**Submission to the NSW Department of Environment and Planning in relation to the 'New M5' Environmental Impact Statement on behalf of the RAPS organisation.**

## Comments and observations on air quality section of the EIS document for the proposed 'WestConnex New M5'

3. Correlation of extinction coefficient and PM10, concentration obtained from M5 East tunnel discharge stack data.

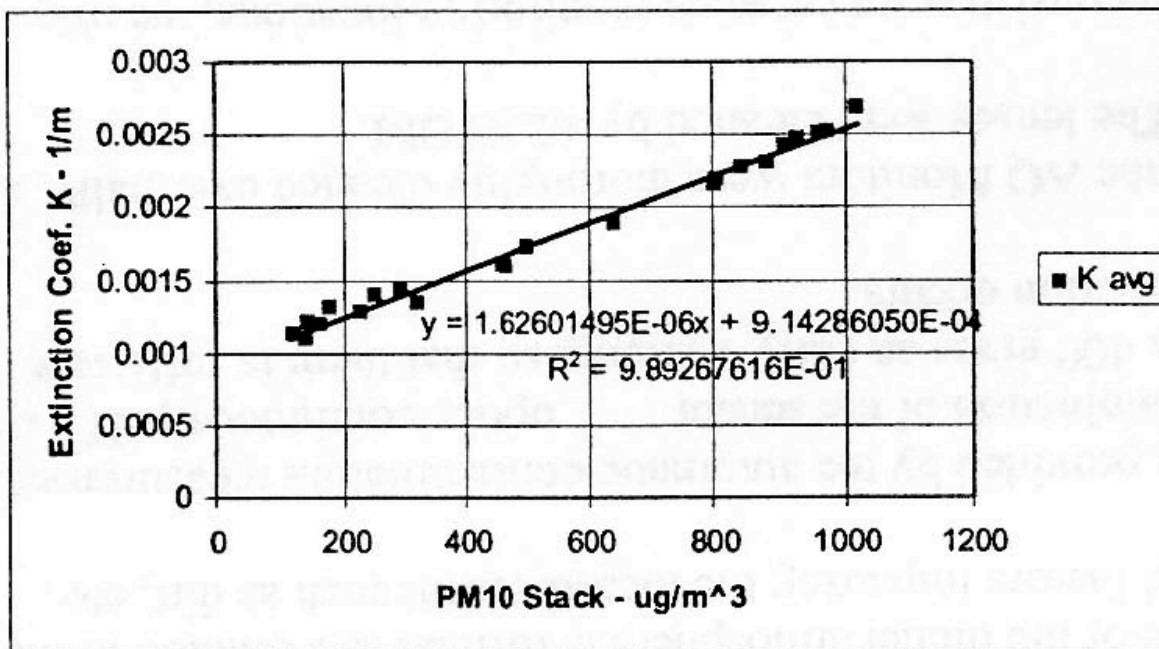
The relationship shown in Figure 3 differs from that defined by PIARC (1995). PIARC (1995) indicates that an extinction coefficient of  $0.005\text{m}^{-1}$  corresponds to a PM10, concentration of  $1000\mu\text{g}/\text{m}^3$ . However, the same PM10, concentration in the M5 East tunnel suggests an extinction coefficient of  $0.0025\text{m}^{-1}$ , i.e., approximately half that predicted by PIARC (1995). Unless stated otherwise, all extinction coefficients predicted in this report are based on the M5 East relationship shown in Figure 3.

It is clear that the PIARC relationship between visibility and particulate matter concentration DID NOT HOLD UNDER THE CONDITIONS FOUND IN THE M5 TUNNEL and that the extinction coefficient to be used for the control inside the tunnel needed to be significantly less if acceptable conditions were to be maintained.

It should be a matter of serious concern that the PIARC conversion factor has been used in spite of the experimental evidence based on local conditions and experience, which demonstrate that it is, in fact, unsuitable and inaccurate.

It is essential that the approach taken by the designers of the Cross City (and the Lane Cove) tunnel be adopted and that all relationships between visibility and gravimetric concentration be based on a locally determined empirical relationship.
